NOTICE OF SWIMMING POOL NON-COMPLIANCE

(Clause 22E, Swimming Pools Act 1992)

Premises to which this notice relates: 61 Trentbridge Road Belrose.

Pool Installation Description: Above-ground swimming pool

1. Defect/non-compliance identified

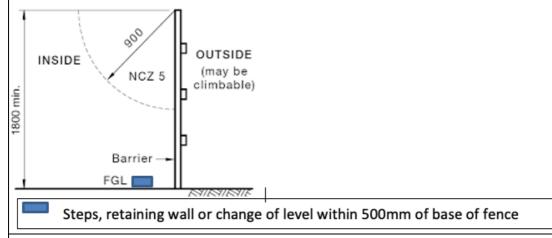
The boundary fence had a ledge on the pool side of the fence that was within 900 mm of the top of the fence (NCZ 5).

The rail can be shielded to prevent children using the rail to climb over the pool fence and into the pool enclosure. If the rail is to be shielded, the minimum angle or splay the shield can be is 60°.

See diagram below for boundary fence no-climb zone.

2. Defect/non-compliance identified

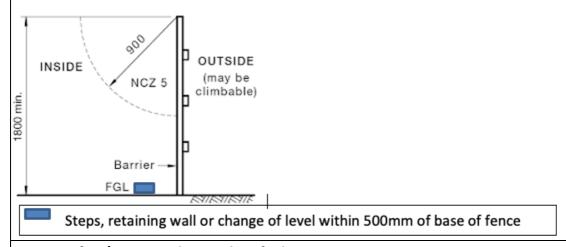
There was a pool vacuum cleaning pole hanging on the fence that was within the fence's Non-Climb Zone (NCZ). All climbable objects are required to be kept clear so that children cannot use any object close to the fence to assist them to climb into the pool enclosure.

Remove the pool vacuum/net pole and support brackets from the fence.

See diagram below for boundary no-climb zone.

Defect/non-compliance identified

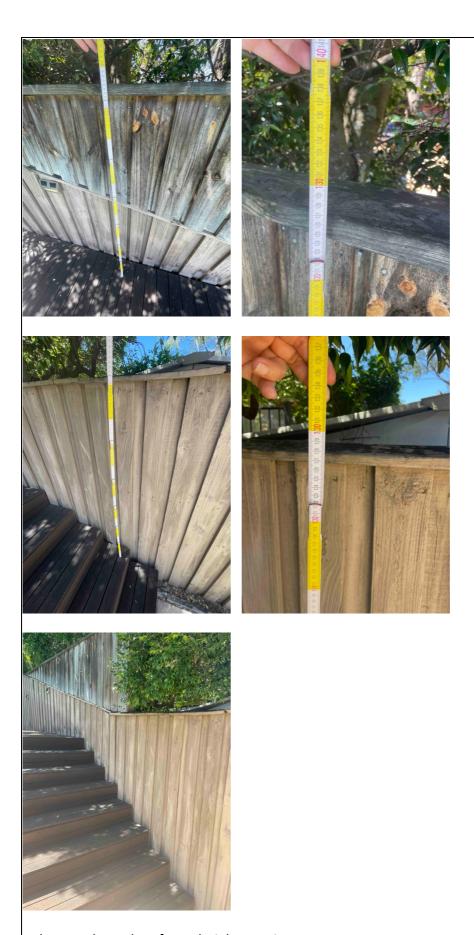
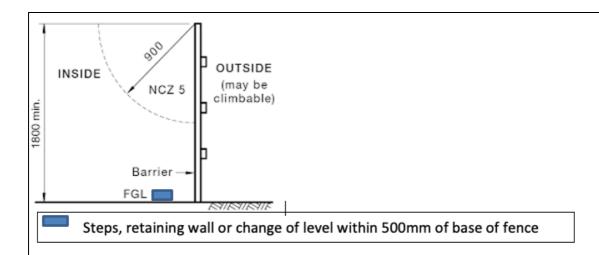
The effective height of the boundary fences was not 1800 mm or more. The height of the fences was measured from the top of the fence to the ground level on the pool side of the fence.

Raise the boundary fences so they are 1800 mm or more in height (measured on the pool side of the fence). The 1800mm height must extend for 900mm past the intersection with the internal barriers. The height of a boundary fence is measured from the top of the fence to the ground level on the pool side of the fence. Where there is an object such as pavers, raised garden bed or decking etc within 500 mm of the boundary fence, the 1800 mm in height is measured to that object and not the ground. Alternatively, any ground or surface object on the pool side of the fence could be lowered or removed (500 mm or more away from the fence) so that the 1800 mm effective height of the fence is achieved. If the fence height is increased, the required 900 mm NCZ 5 is required to be measured from the top of the fence so that any fence extension construction provided on top of the existing fence must not have footholds greater than 10 mm wide within 900 mm of the top of the extended fence.

Below see boundary fence height requirements.

Below are some examples of increasing boundary fence height.
